SITE SUPPLEMENTAL INSTRUCTION

PROJECT: Forestside Estates
Attmar & Palleschi Drive
Brampton, Ontario

SITE SI NO. E-6

PURPOSE: Revised as per Arch SI A01 and Mech S SI M-2.

TITLE		TYPICAL SUITE LAYOUT ELECTRICAL	
PROJECT		BRAMPTON STACKED FORESTSIDE ESTATES	
DRAWN		CHECKED	SCALE
SP	MG		1/75
DATE		PROJECT	DRAWING
MAY, 2019	18-017		E-8
			OF 16

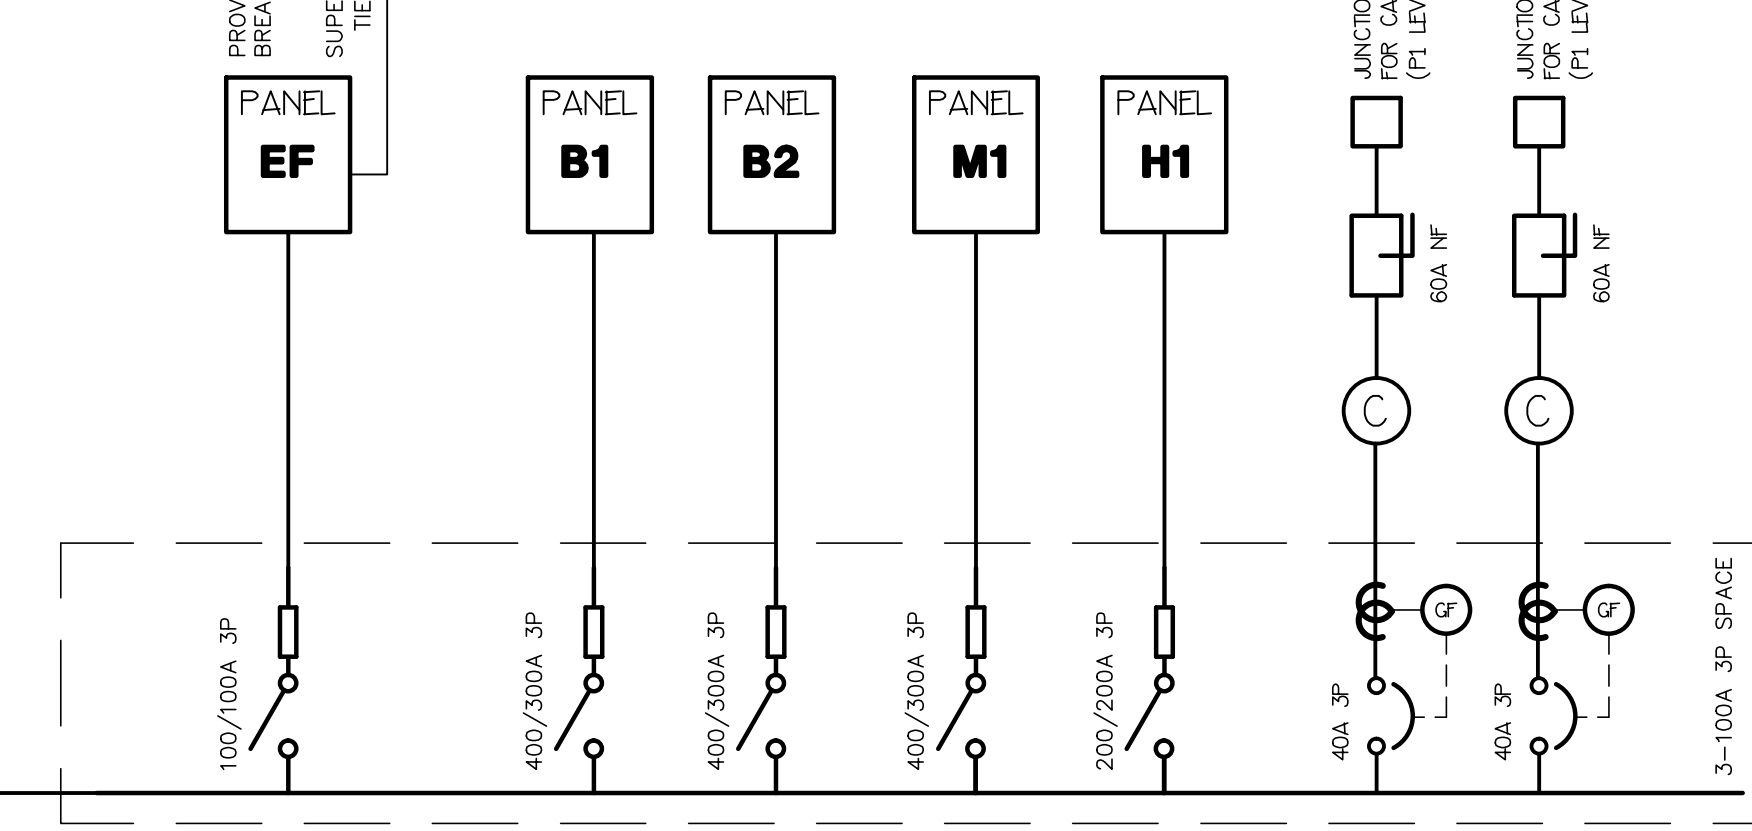
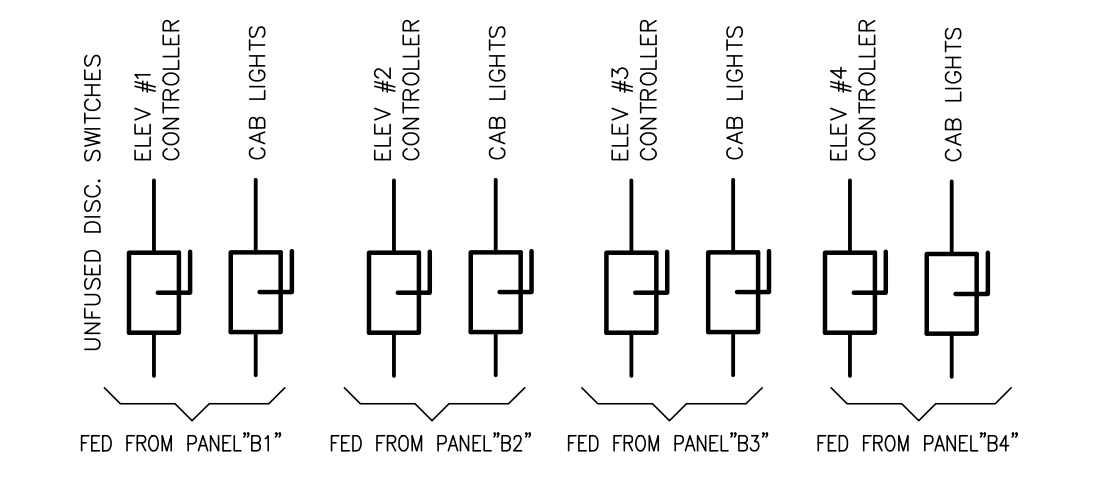
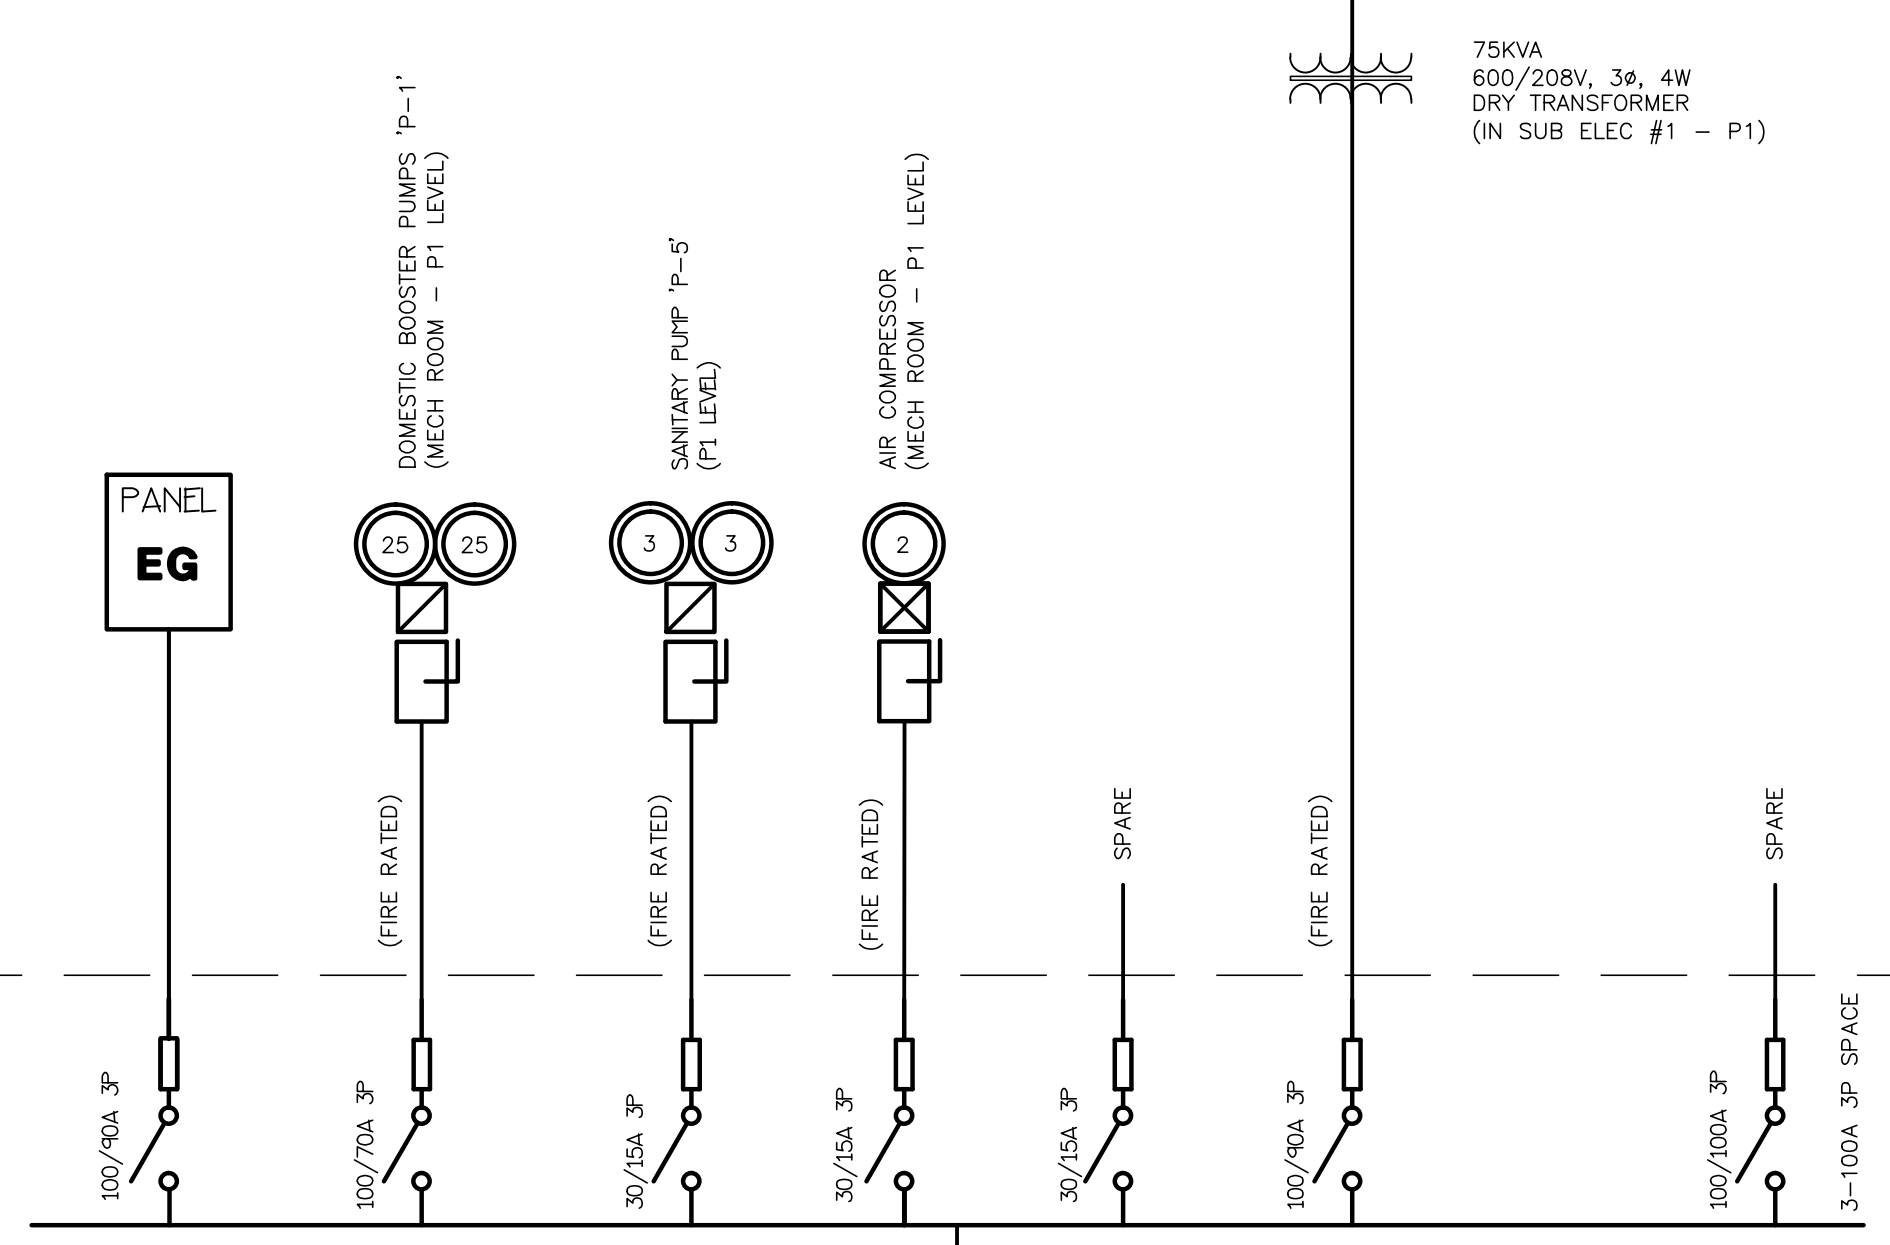
6.0 Reference Drawings E-12 (Single Line Diagram - Electrical) Issued

6.1 Revise: Single line diagram as shown.
